Proposal Request

Project:	Twin Falls Fire Station 2	PR No.:	PR-02
Project No.:	20-041	Date Issued:	May 27, 2022
Owner:	City of Twin Falls 214 Cheney Drive Twin Falls, ID 83301	Issued To:	Starr Corporation 2995 E 3600 N Twin Falls, ID 83301
Contract Date:	April 12, 2022	Attn:	Jason Derricott

ITEM 1: PR-02 Dedication Plaque Design and Room Signage Schedule

Sheet No: A3.10

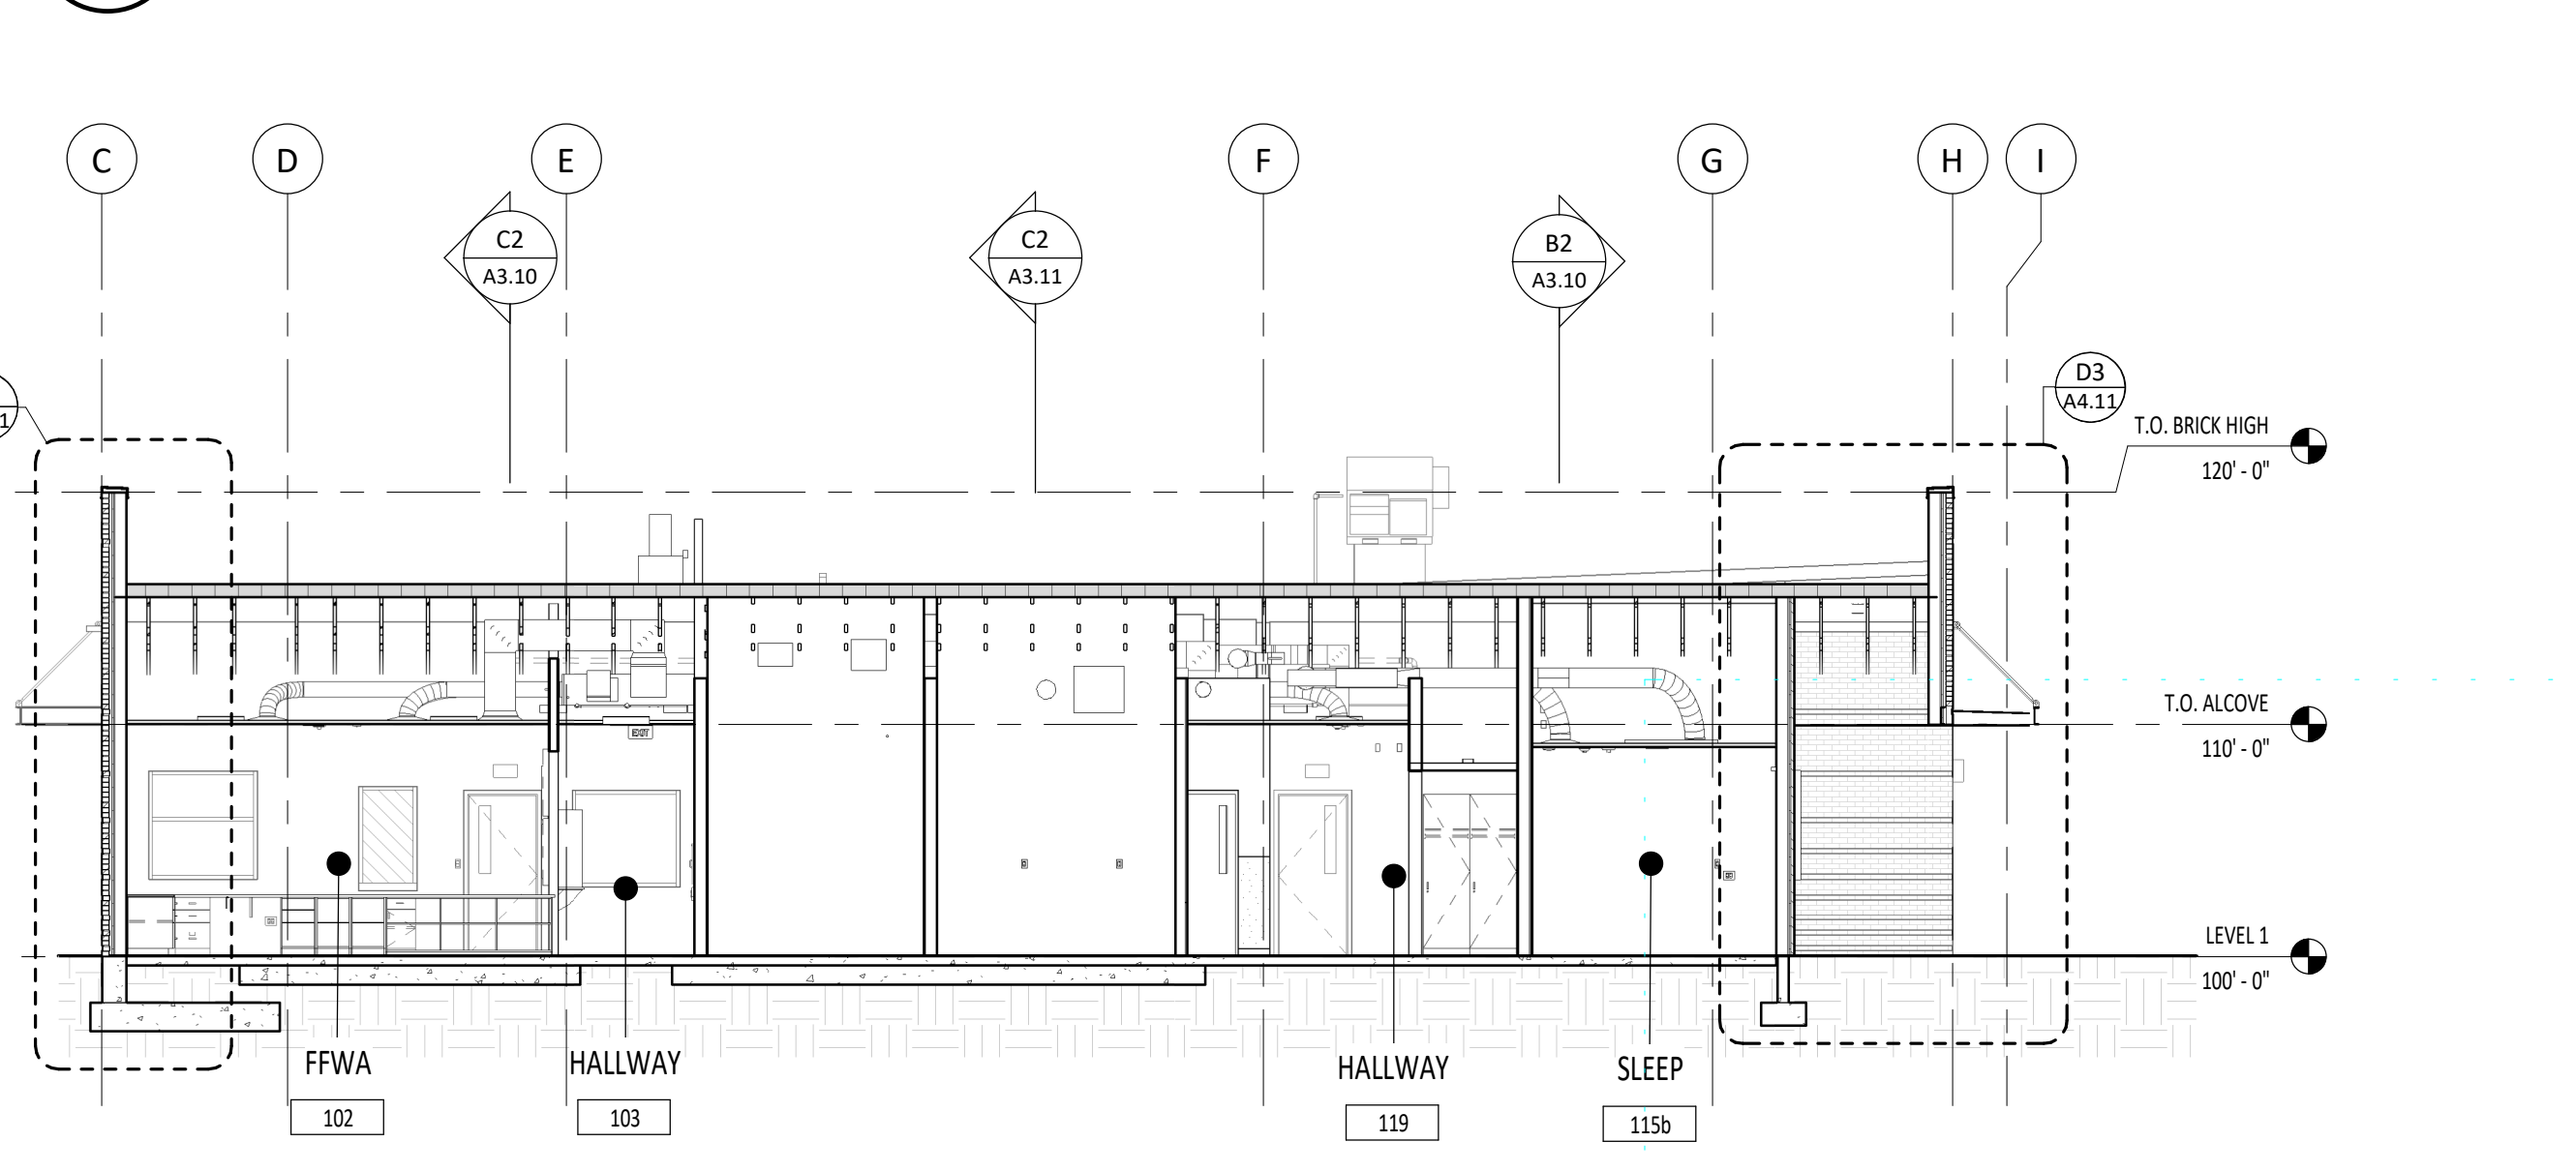
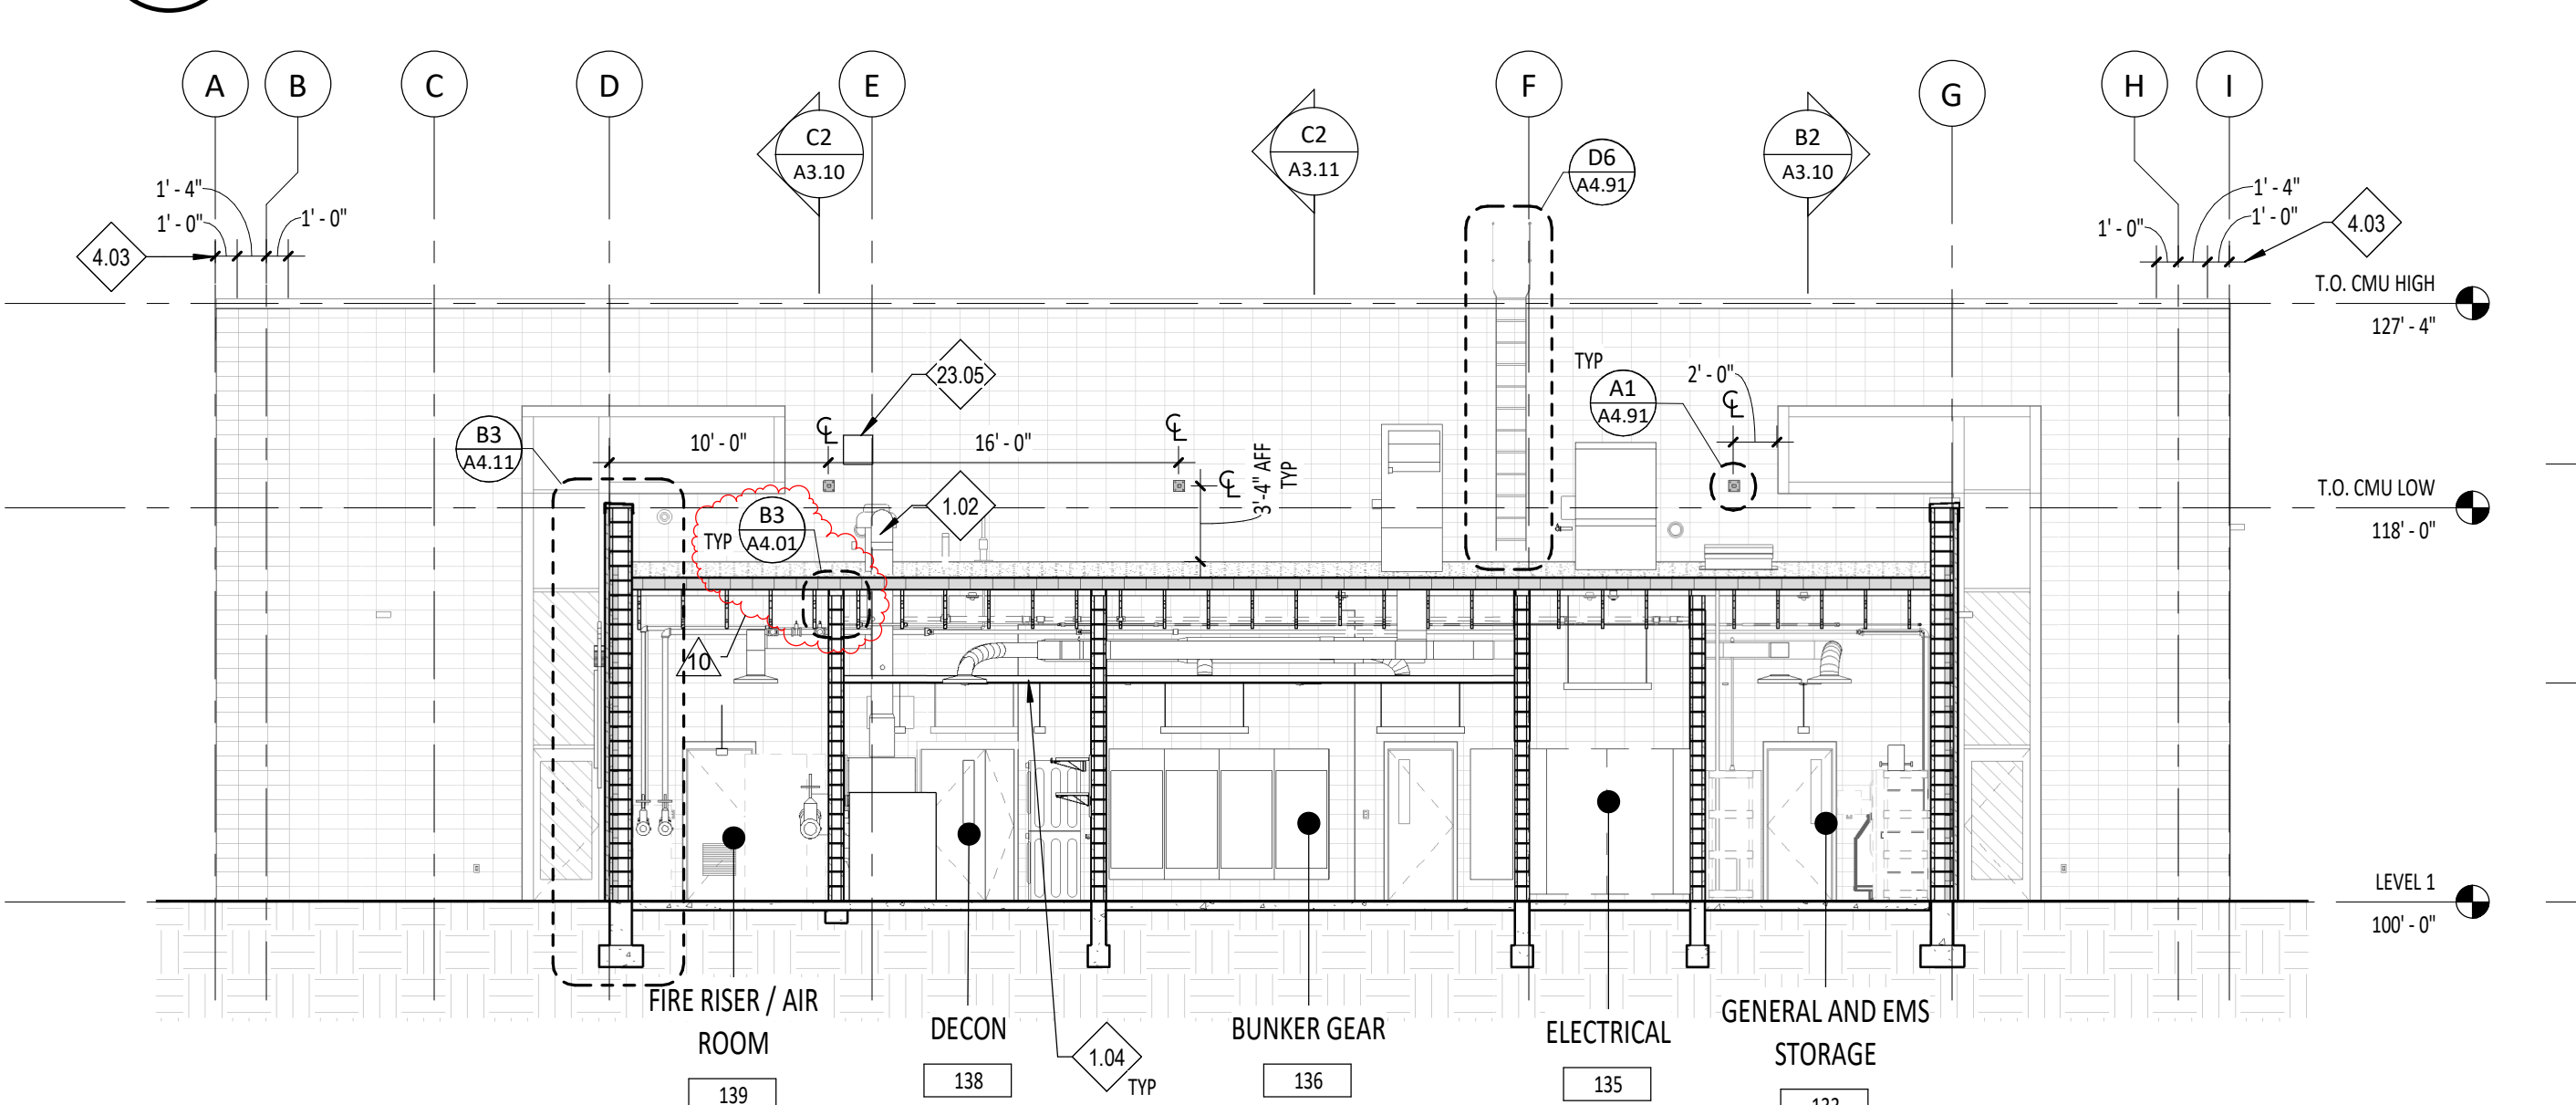
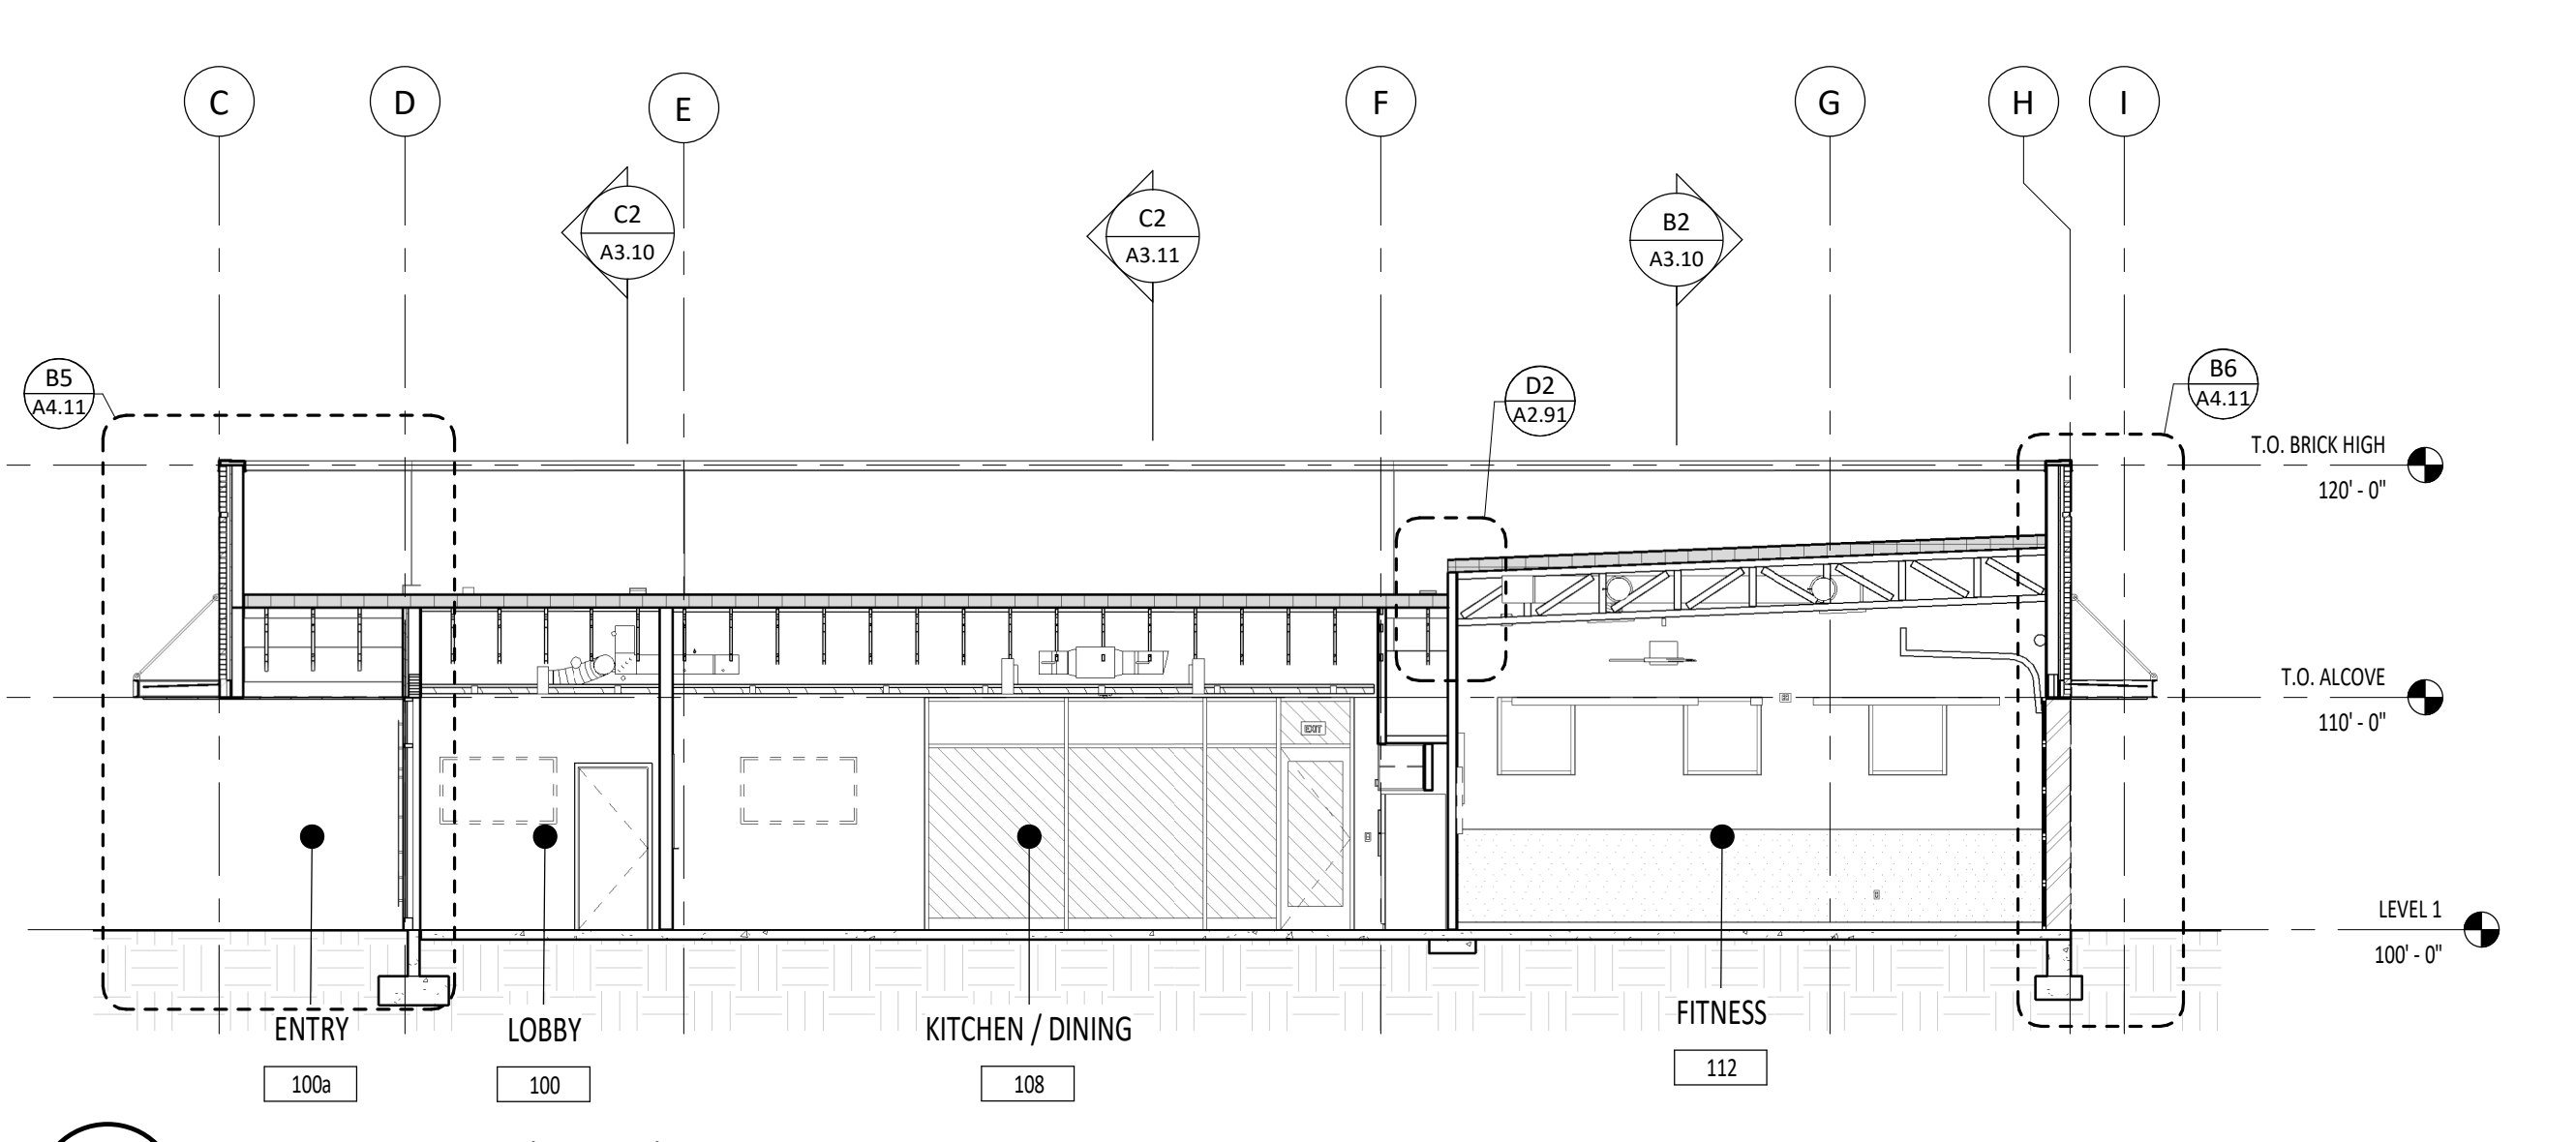
- E1/A3.10 – indicated typical location detail (B3/A4.01) for non bearing sloped CMU walls that go to deck
